寄件者: Chong Hermose [REDACTED]
寄件日期: 2026年06月27日星期六 14:34
收件者: tpbpd/PLAND
副本: Jason Sek Hei WONG/PLAND
主旨: s16 Planning application No. A/YL-SK/439 - 回應部門意見 (DSD)
附件: TEMPORARY DRAINAGE PROPOSAL_SK439_FULLSET.pdf

**TEMPORARY DRAINAGE PROPOSAL FOR THE PROPOSED TEMPORARY PLACE OF RECREATION SPORTS OR CULTURE (HOBBY FARM) AND ASSOCIATED LAND FILLING FOR A PERIOD OF 3 YEARS AT LOTS 1430 (PART), 1431 (PART), 1439(PART) AND 1440 (PART) IN D.D.114, SHEK KONG, YUEN LONG
A/YL-SK-439**

ISSUE 2 (June 2026)

Comments from Chief Engineer/Mainland North, Drainage Services Department (Contact Person:- Mr. Jeff TSE C.W., Tel: 3965 8921)

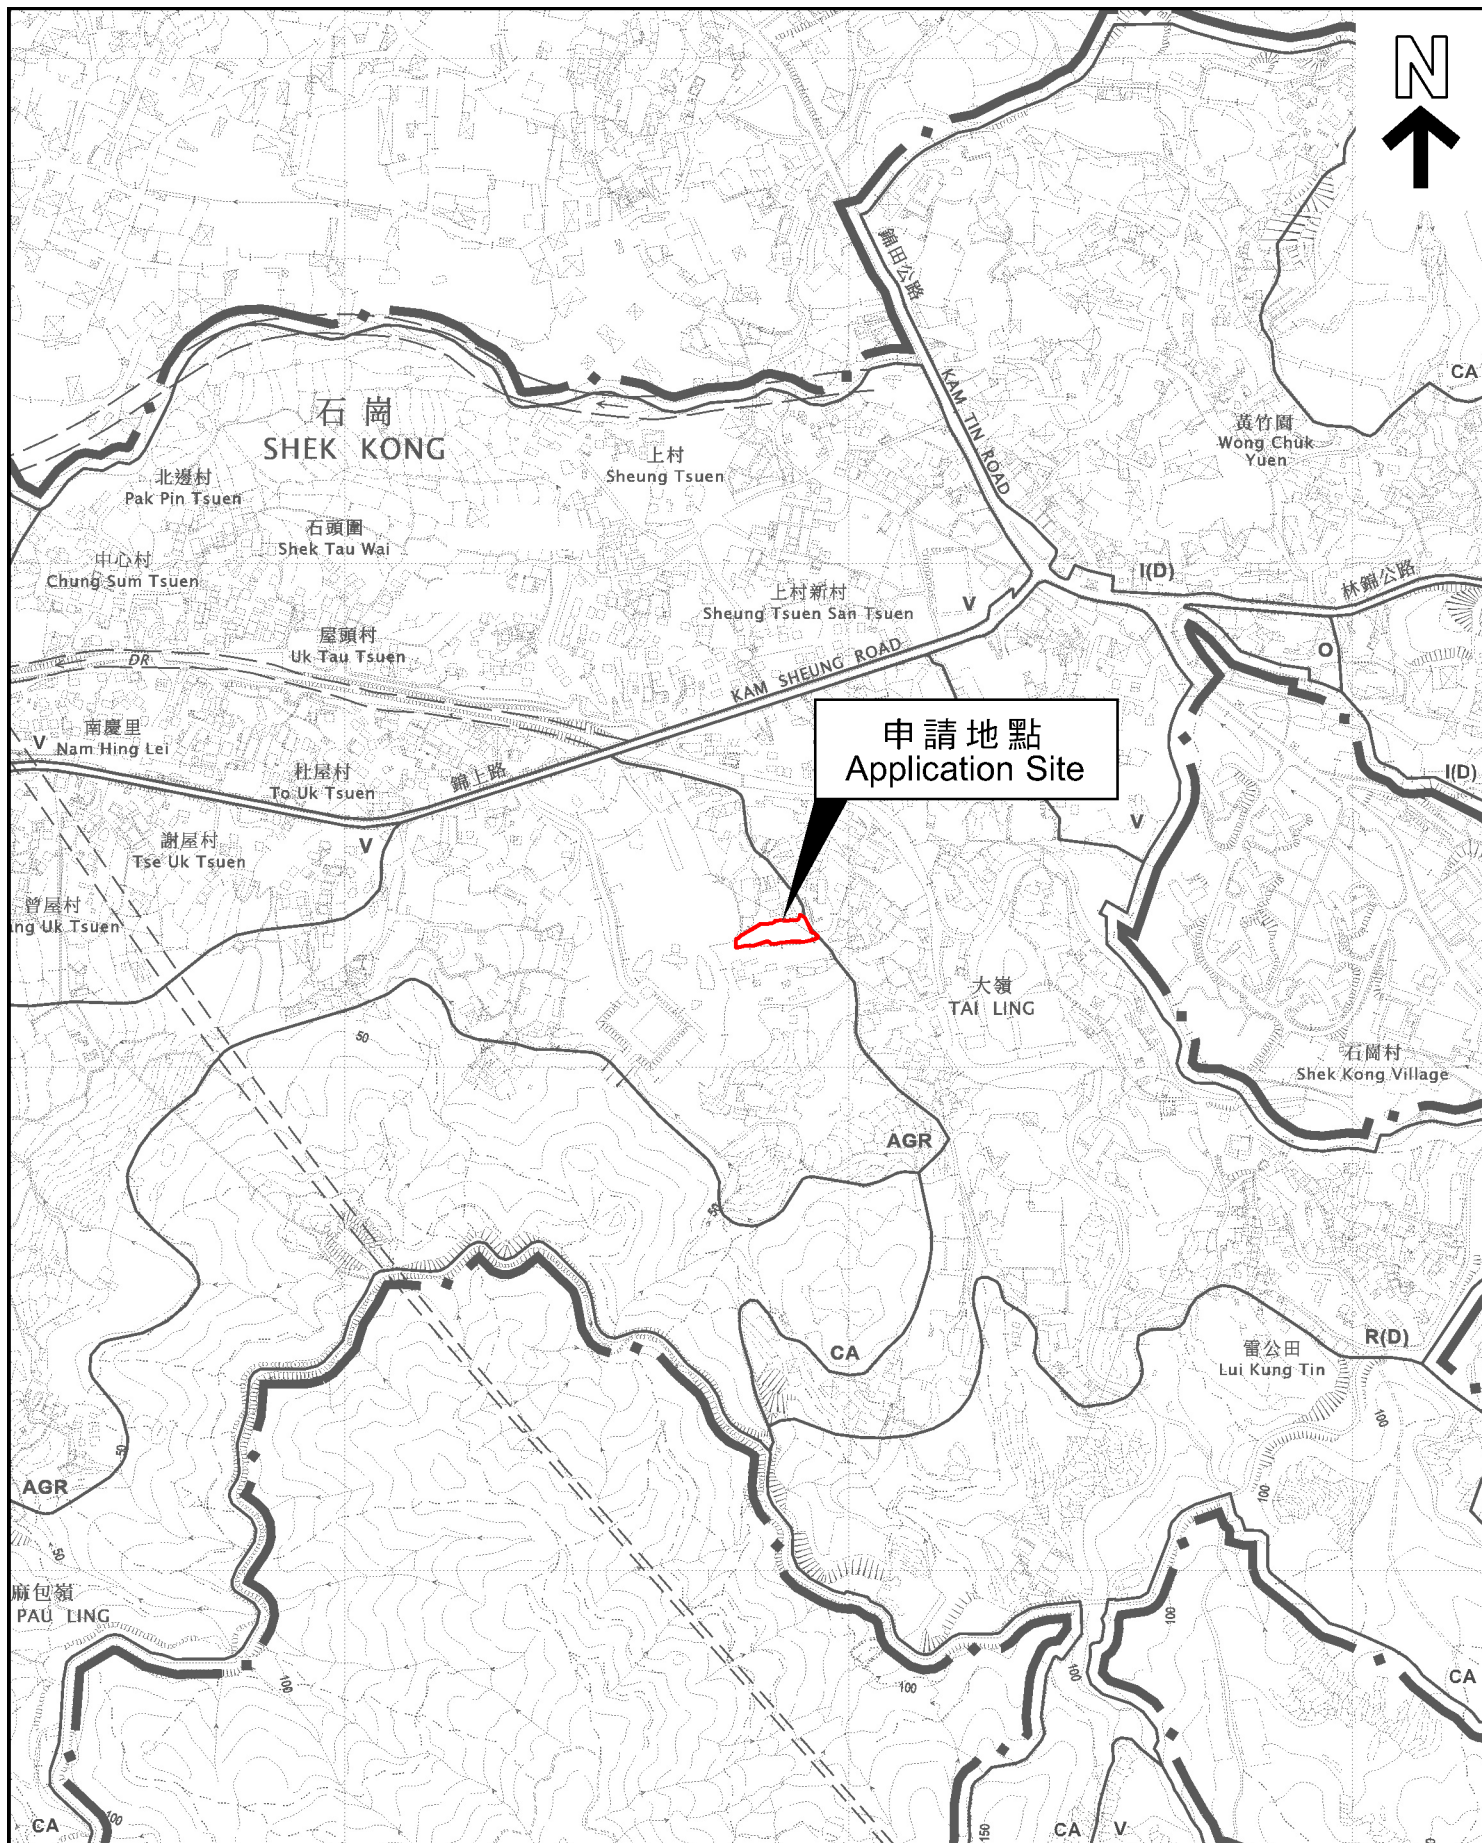
v) Catchpit should be provided at the turning point of the proposed u-channel.	Noted, catchpits are added at the turning point.
vi) Separation should be provided at the start point(s) of the proposed peripheral surface channel. Please review.	Noted, original CP1 is relocated and proposed peripheral surface channels are separated.
vii) According to the drainage plan in Appendix D, it is noted that the proposed invert level of CP6 at upstream (+41.32 mPD) is lower than the downstream catchpit CP7 (+41.44 PmD), which is not desirable from drainage point of view. Please review	Noted, the invert levels of catchpit are reviewed and updated in Appendix D and Appendix E.

Comment	Response
the invert level of all the proposed catchpit with adequate gradient.	
viii) As noted, the gradient of the proposed 375mm pipe connection from the last catchpit with sand trap (TCP 8) to the existing village drain is 1:10, which is quite steep. Please check its velocity and review the gradient and the size of the proposed drainage facility accordingly.	Noted, the gradient of the proposed pipe connection is reviewed and updated in Appendix D and Appendix E.
ix) Please indicate the size of all the existing village drain on the drainage plan for review.	Noted, the size of the existing village drain is indicated in Appendix D.

x) Please provide the connection details at the proposed discharge point with relevant levels (i.e. C.L., I.L., catchpit/watercourse bottom level, etc.) on the drainage plan for review.	Noted, the connection details are added in Appendix D.
xi) The existing village drain, to which the applicant proposed to discharge the stormwater from the subject site was not maintained by this office. The applicant(s) shall resolve any conflict/disagreement arisen for discharging the runoff from the application site(s) to the proposed discharge point(s). In the case that it is a local village drains, DO/YL should be consulted. Moreover, the applicant(s) should ensure that this drainage system and the existing downstream drains/channels/streams have adequate capacity to convey the additional runoff from the application site(s). Regular maintenance should be carried out by the applicant(s) to avoid blockage of the system.	Noted with thanks.

Appendix C
Location Plan and Photos of the Existing Drainage

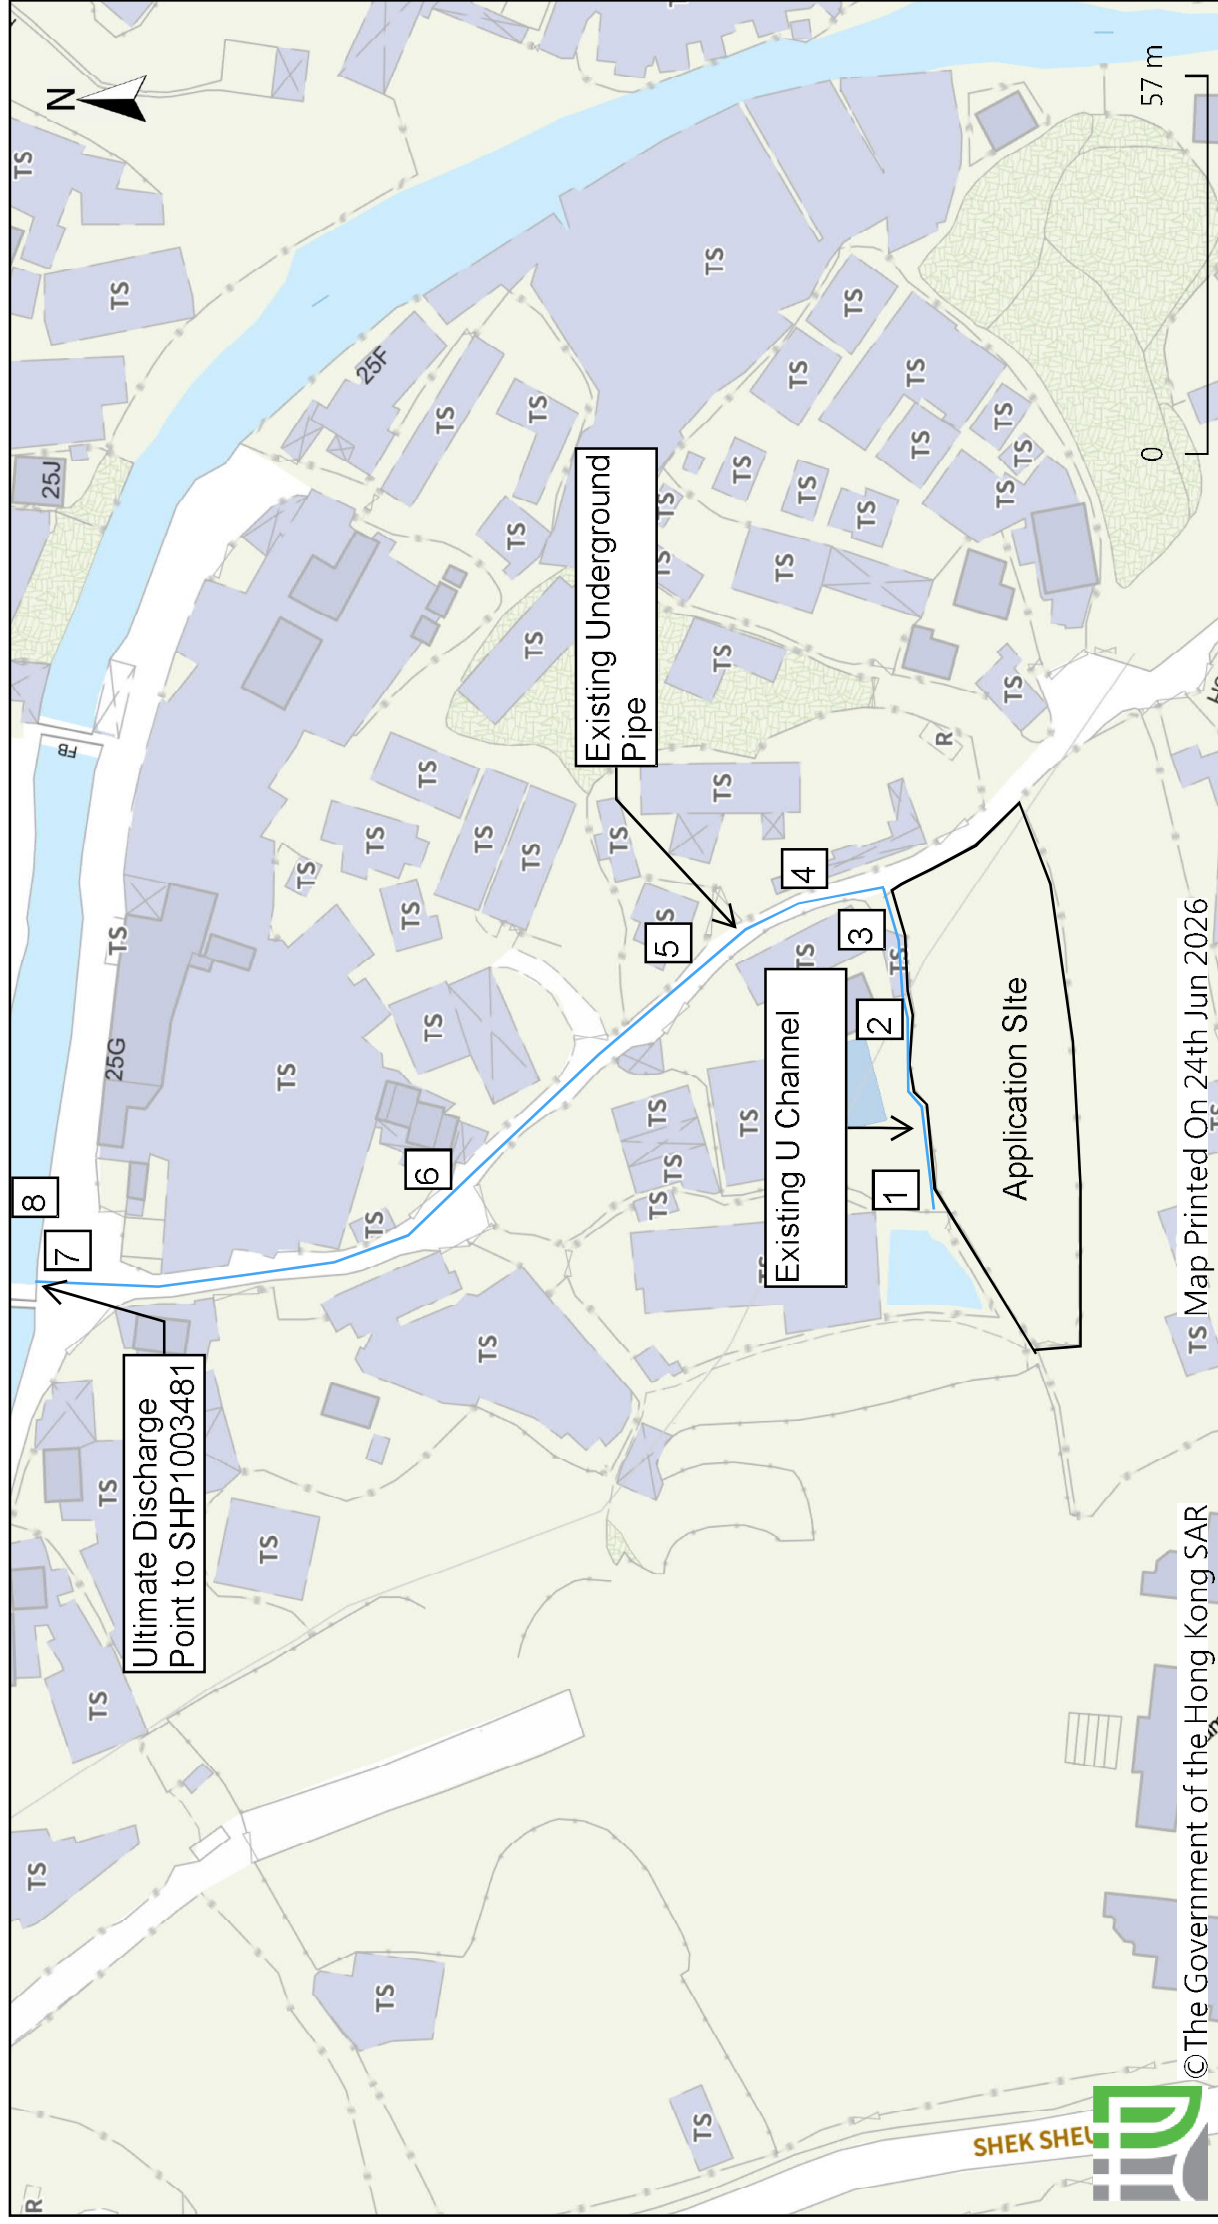
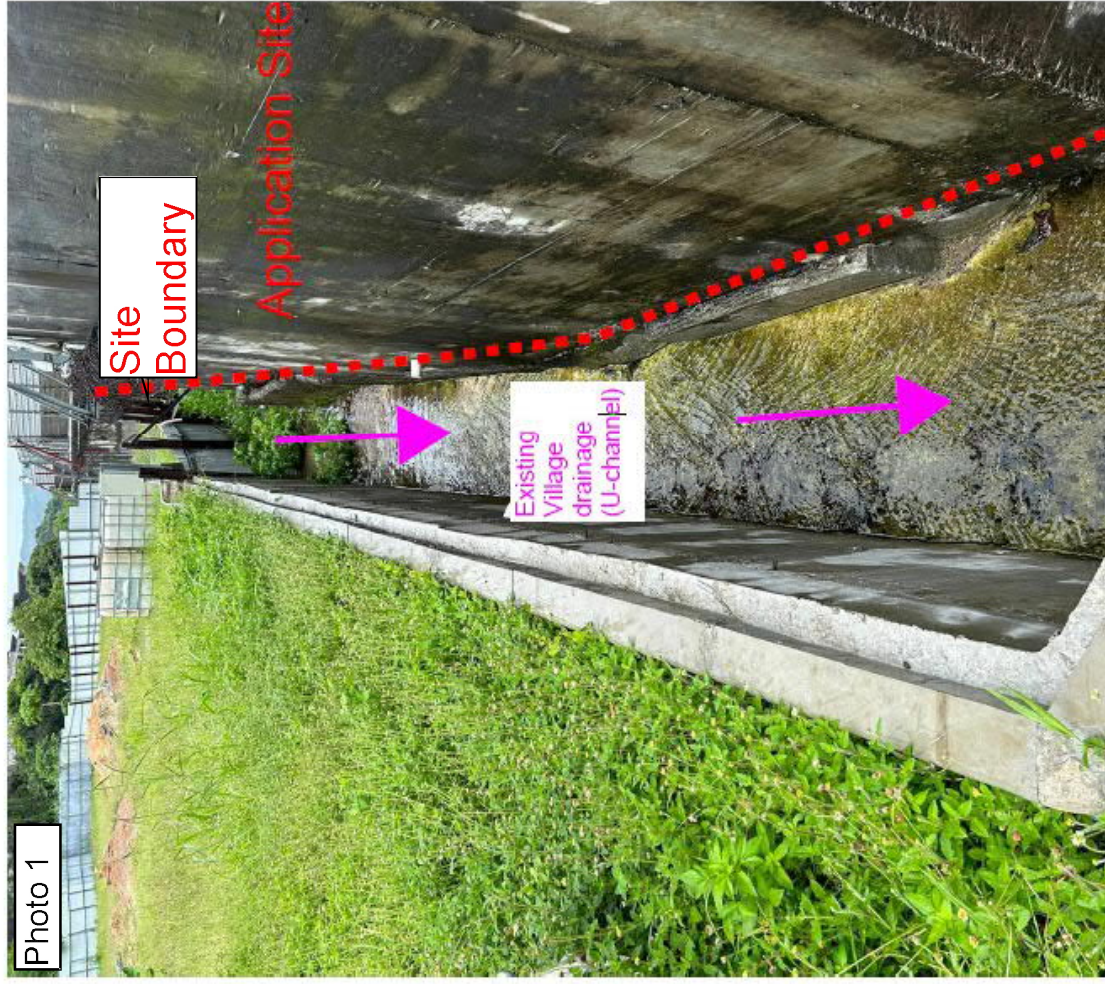
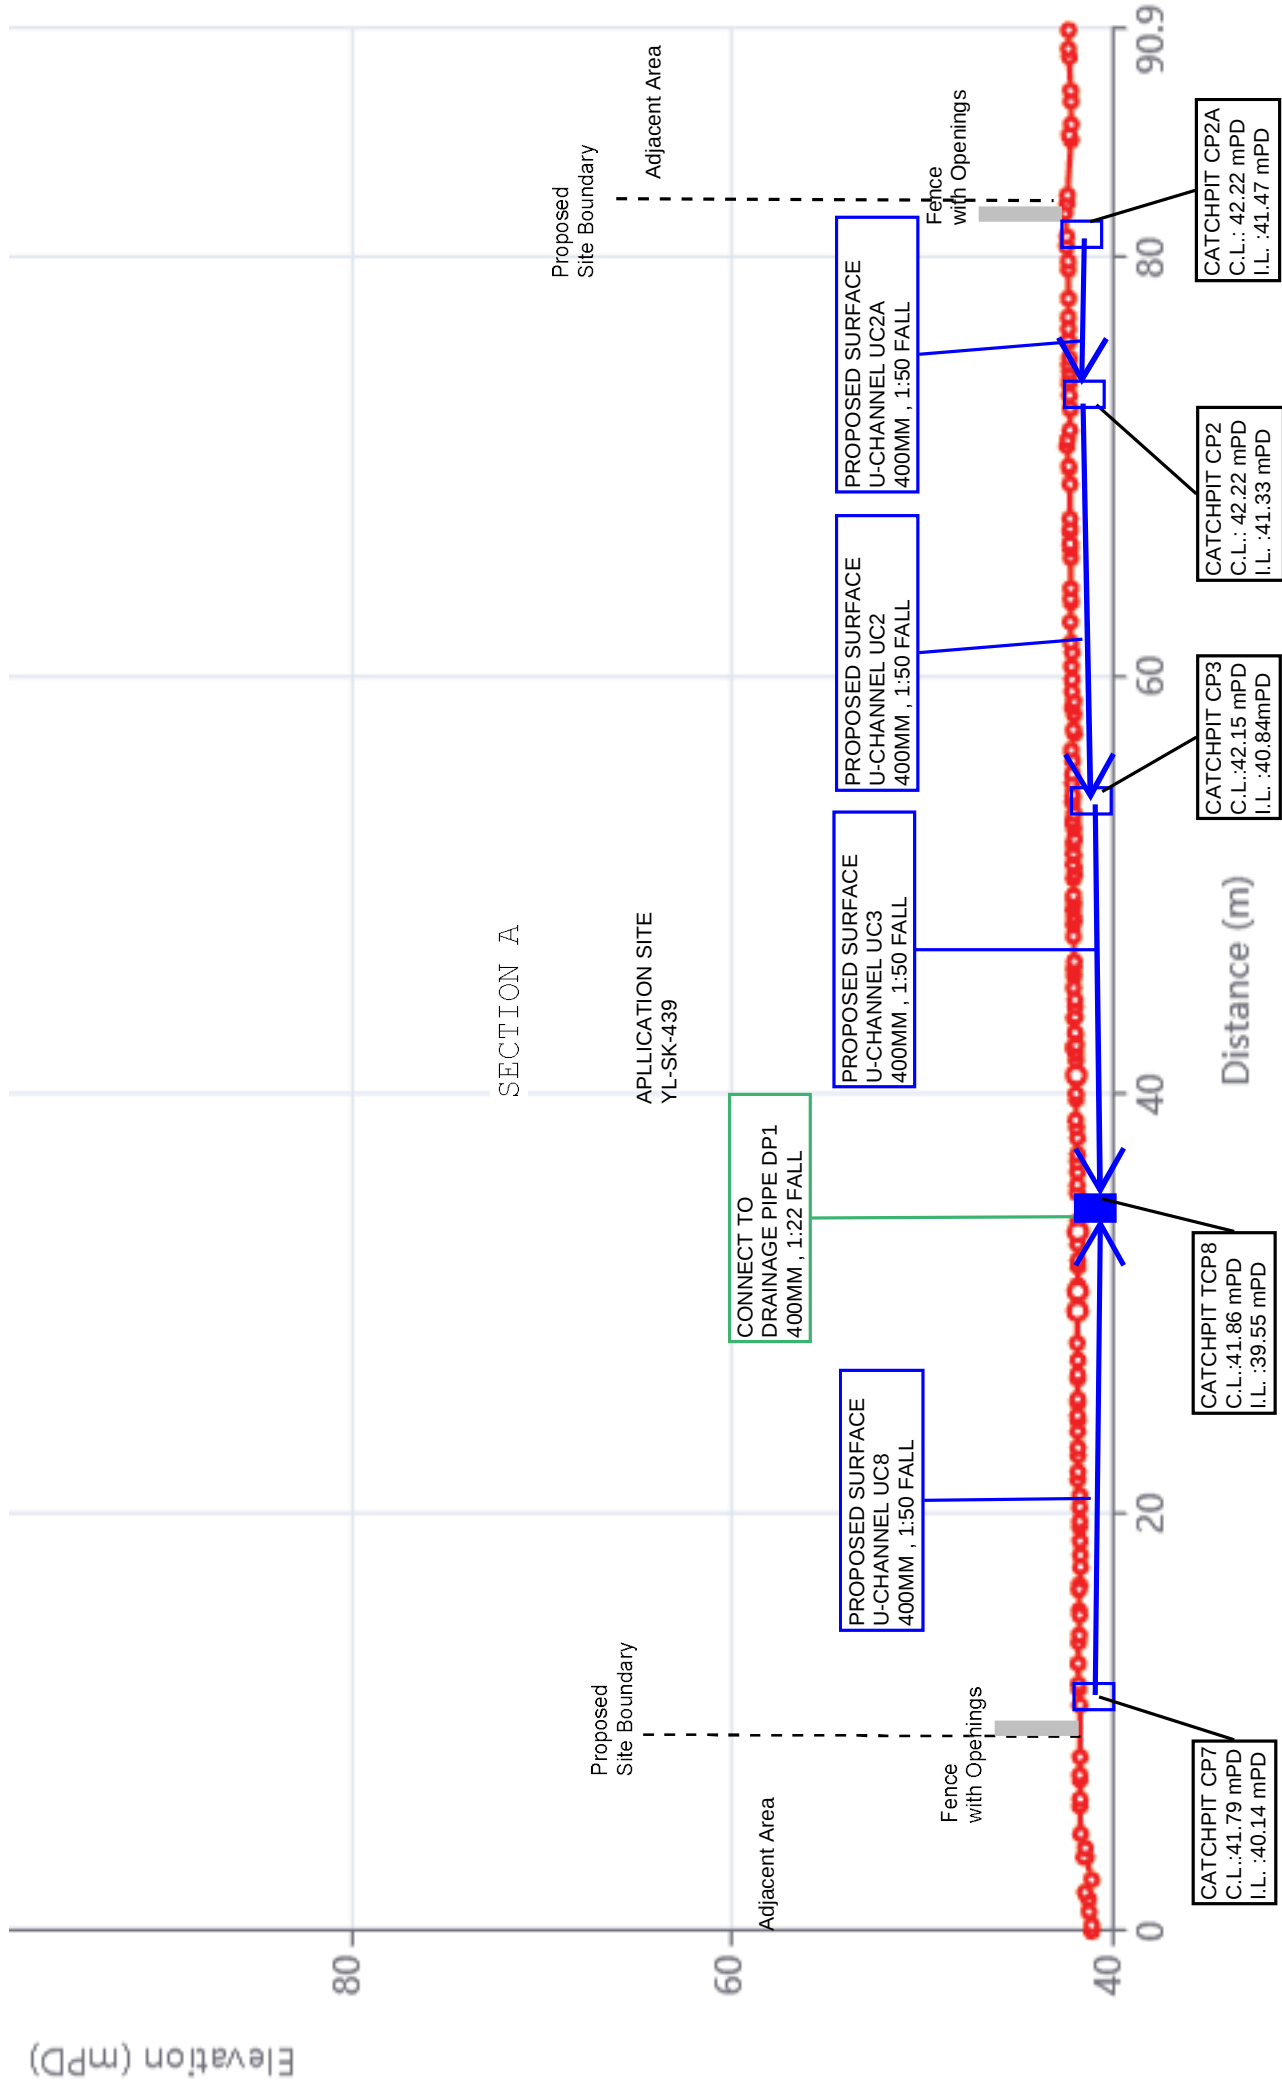
Comment	Response
i) Please indicate clearly the full alignment of the discharge path via the existing 1200mm width village drain from the application site all the way down to the ultimate discharge point (e.g. a well-established stream course/public drainage system). Since there is no record of the said discharge path of the said 1200mm width village drain, please provide more site photos at different locations and views along the discharge path to demonstrate its presence and existing condition.	Noted, site photos at different locations and views are added in Appendix C.
ii) Please advise and indicate the locations of photos taken for review.	Noted, locations of site photos taken are added in Appendix C.
iii) Please advise if any site formation/levelling works to be carried out under this application. Cross sections showing the existing and proposed ground levels of the captioned site with respect to the adjacent areas should be given. Please be reminded that peripheral surface channels shall be provided along the site boundary at the existing/original ground level (instead of the revised ground level) to collect the surface runoff accrued on the application site and to intercept the overland flow from the adjacent lands.	Noted, there is no site formation in this application site. Peripheral surface channels will be provided along the site boundary at the existing/original ground level.
